| APPLICATION NO. | FILING DATE | FIRST NAMED INVENTOR | ATTORNEY DOCKET NO. | CONFIRMATION NO. |
|-----------------|-------------|----------------------|---------------------|------------------|
| 10/518,326 | 12/15/2004 | Takaya Sato | 040-113 | 6733 |

| Office Action Summary | Application No. 10/518,326 | Applicant(s) SATO ET AL. | |

DETAILED ACTION

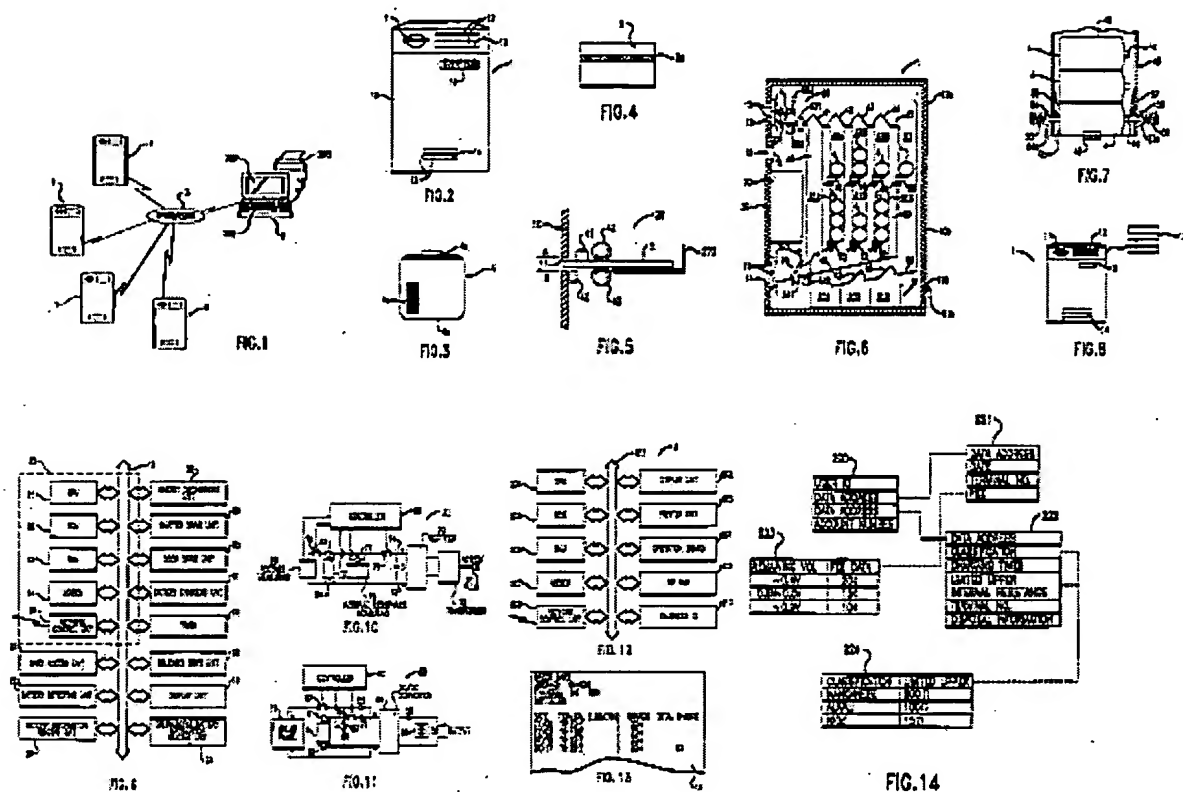
a central processing unit (CPU) (21) (applicant's charging processor), which is a part of the electric unit (70) (applicant's charging equipment for said rapid charge battery) as shown in Fig. 6, and;

a network management apparatus (2) or host computer system and controller (applicant's charging information center) which has data base to store user information thru the provision of a card (5) in the card unit access (26) to be input to the card entrance (11) as referred in Fig. 4 (col. 3, lines 58-67) and a battery charging unit (31) (applicant's charging unit). Uchida also discloses (col. 3, lines 32-43) that the network management apparatus (2), or host computer system and controller, includes an operation board (201) and a printer unit (203), and is connected to the battery charging apparatus (1) by a communication network line (3)(applicant's communication network), , for example, a PSTN (Public Switched Telephone Network), an ISDN (Integrated Service Digital Network), a wireless telephone network, thus meeting the limitation of," a charging information center which has a data base to store user information therein and a charging unit, wherein when the user utilizes said charging processor, said charging

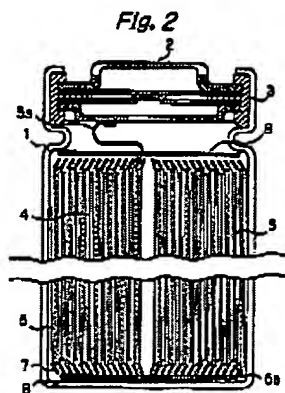
10. As per claims 4-5, Uchida discloses (col. 3, line 55) and shows in Fig. 3, a battery (4) for use in the battery charging apparatus (1) (applicant's charging system for the rapid charge battery) including a pair of terminals (4a), (4b) (applicant's positive and negative electrodes, respectively) and having a bar code (4c) in which, battery classification, such as the type of battery (e.g. manganese battery, alkali battery, lithium battery, Ni-Cd battery, etc) a battery charging time etc., may be recorded.

Uchida differs from the claimed invention because he does not specifically disclose that the battery charging apparatus is a non aqueous electrolyte secondary battery which comprises positive and negative electrodes having materials that occlude and release a lithium ion and containing non aqueous electrolyte having lithium salt and organic solvent.

FIG. 6

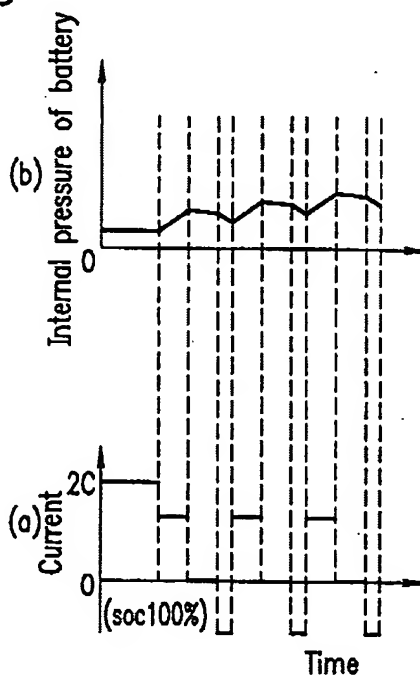
Minamiura discloses (col. 5, lines 42-51) and shows in Fig.6 that after the battery pack is charged with a constant current at a rate of 2 C until the remaining battery capacity (SOC) reaches 100%, charging at a low rate of about 0.3-1.5 C, a suspension of charging, and discharging of the battery pack may be repeated in this order as shown in part (a) of Fig. 6. The charging at a low rate, the suspension of charging, and the discharging of the battery pack are each performed for an appropriate time period of about 10 seconds to about 40 minutes (representing applicant's different time and current for each time period).
